**MONTGOMERY COUNTY DEPARTMENT OF PARK AND PLANNING**

**MEMORANDUM**

**REVIEW TYPE:** Preliminary Plan Review

**PROJECT NAME:** Wilton Oaks

**PRELIMINARY PLAN  
WILTON OAKS  
PROPOSED LOTS 14-17**

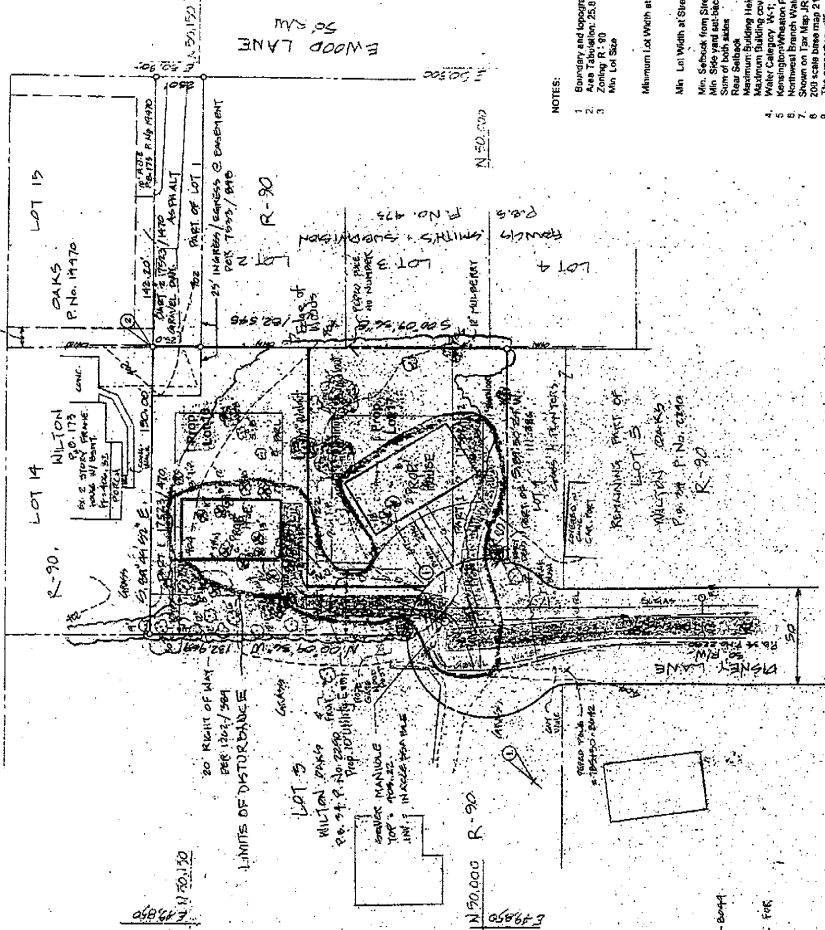
As a property owner, I am writing to voice my concerns about the proposed subdivision (Wilton Oaks, M-NCPPC No. 1-03047). There is a lack of adequate public facilities: Disney Lane is narrow and not much more than a driveway. Two cars can't pass each other without one going off road into the grass. There is no way for trucks or emergency vehicles to turn around. We occasionally see a truck going through my yard or my neighbor, Mr. Thomas Tedder's yard, just to turn around at the dead end of Disney Lane. The dedicated cul-de-sac at the end of Disney Lane doesn't even exist.

Mr. Leon Trager, the owner of the vacant property in question, has tried three times (including the current attempt) to develop this property. Each time he has been asked to make improvements to Disney Lane. As the owner of property adjacent to his, Mr. Trager didn't even provide me a copy of the proposed development plans - I had to find out about it from my neighbor, Mr. Thomas Tedder - I am extremely concerned about the attempt at development of the property when the proposed plan doesn't show any improvements in public facilities.

Mr. Trager developed the entire east side of Disney Lane (on either side of my house) without making any improvements or doing any storm water work. One result is that water collects in my yard and my basement floods with every hard rain. After every rain we have a large standing body of water on the east side of Disney Lane - "Lake Leon" as we call it. The proposed development would bring the total to six lots in a row on a storm water waiver. During Mr. Trager's last subdivision development on Disney Lane, he signed documentation stating that he would participate in Disney Lane road improvements. He also had to leave behind a bond, to ensure he would solve some of the problems he left behind. If Mr. Trager develops the end of Disney Lane, he should have to install the cul-de-sac to code and improve the street to get rid of "Lake Leon". This would need to include storm water management. He has access to the south and to the east to direct and manage his runoff.

- 1) Prior to recording of plat applicant to submit final house location, grading and tree preservation plan for technical staff review and approval
- 2) Compliance with the conditions of approval of the MCDPS stormwater management approval
- 3) Access and improvements as required to be approved by MCDPWT prior to recordation of plat(s)
- 4) This preliminary plan will remain valid for thirty-seven (37) months from the date of mailing of the Planning Board opinion. Prior to this date, a final record plat must be recorded for all property delineated on the approved preliminary plan, or a request for an extension must be filed
